Duke Power  
Catawba Nuclear Station  
4800 Concord Road / CN01VP  
York, SC 29745-9635

Subject: Duke Energy Corporation  
Catawba Nuclear Station, Units 1 and 2  
Docket Numbers 50-413 and 50-414  
Proposed Technical Specification Amendment  
Technical Specification 3.7.16, Spent Fuel  
Assembly Storage, and 4.3, Fuel Storage

Table 3.7.16-1

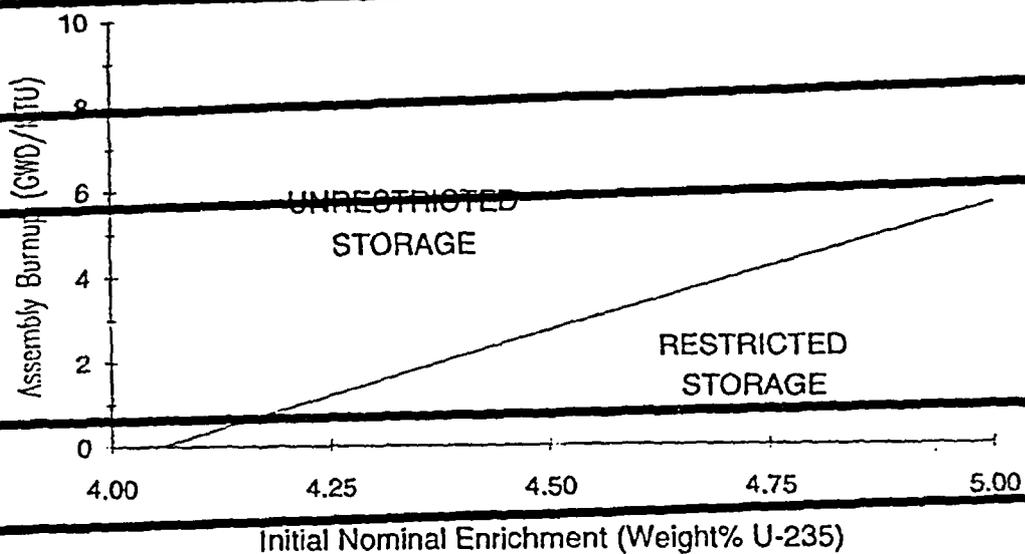
- **Table 3.7.16-1:** As discussed above, this table is deleted. The revised criticality analysis described in Attachment 4 removes any burnup requirements from Unrestricted storage of LEU fuel.

DELETE THIS TABLE

Table 3.7.16 ← 1

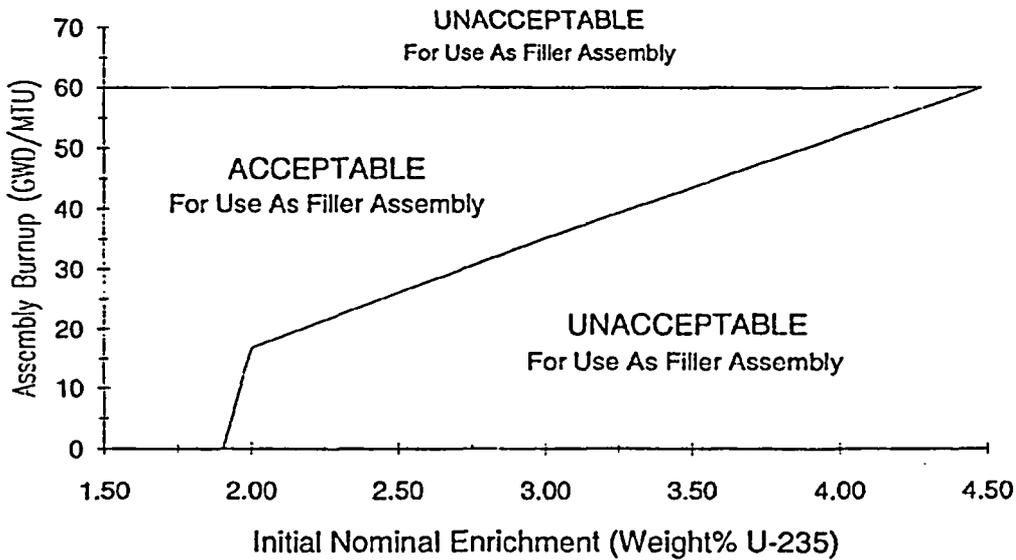
- **Table 3.7.16-2:** This table currently defines minimum burnup requirements for LEU assemblies to qualify as Filler fuel for the Restricted / Filler storage configuration shown in TS Figure 3.7.16-1. This table is retained here, for compatibility with the approved TS changes for the MOX LTAs (Reference 1), which specify that MOX LTAs must be stored as Restricted assemblies, with LEU fuel assemblies as Fillers. However, because TS Table 3.7.16-1 is eliminated, TS Table 3.7.16-2 will be renumbered as TS Table 3.7.16-1.

Figure 3.7.16-1  
Required 3 out of 4 Loading Pattern for Restricted Storage

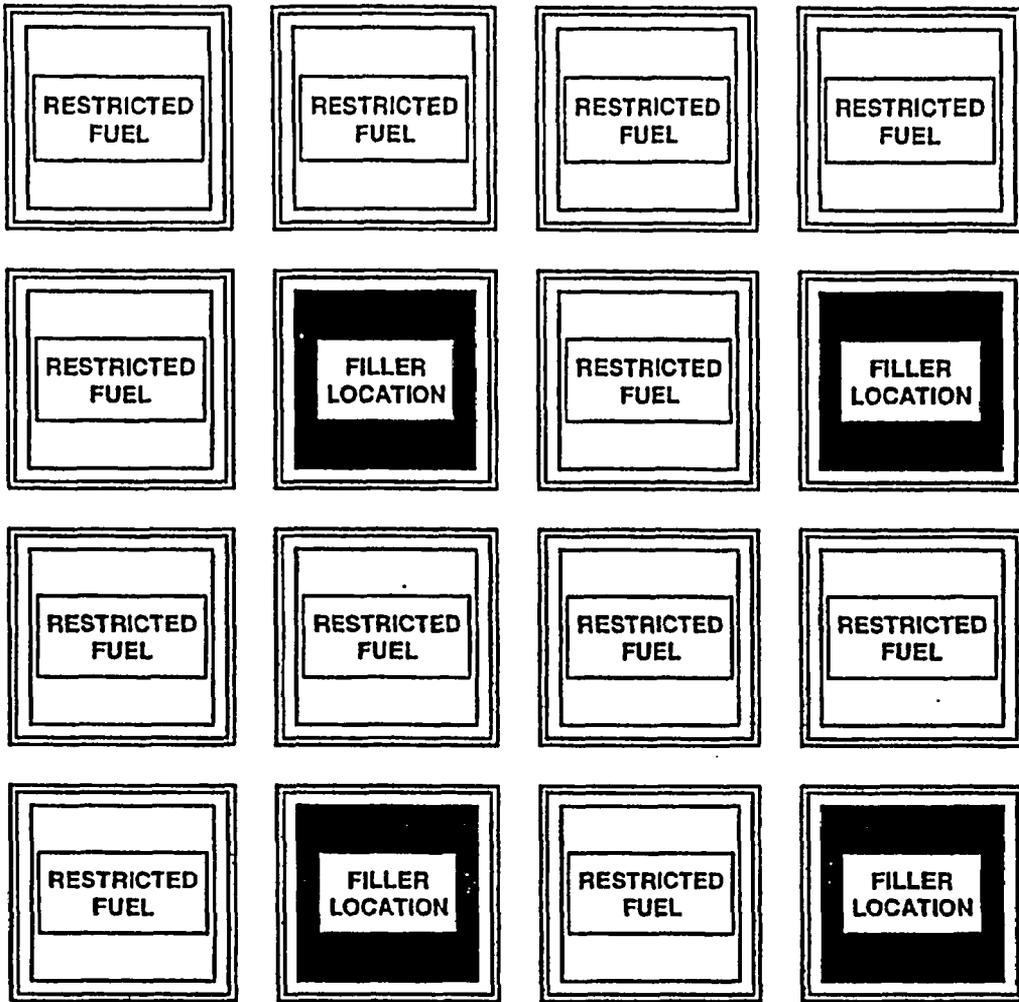
- **Figure 3.7.16-1:** This figure illustrates the loading configuration for Restricted / Filler fuel storage in the Catawba SFPs. The definition of Restricted fuel is revised on this figure, to remove the reference to current TS Table 3.7.16-1. As noted above, the revised Catawba SFP criticality analysis eliminates the need to store any LEU fuel as Restricted fuel.

Any row bounded by an Unrestricted Storage Area shall contain a combination of ~~restricted fuel assemblies~~ and filler locations arranged such that no ~~restricted fuel assemblies~~ are adjacent to each other. Example: In the figure above, row 1 or column 1 can not be adjacent to an Unrestricted Storage Area, but row 4 or column 4 can be.
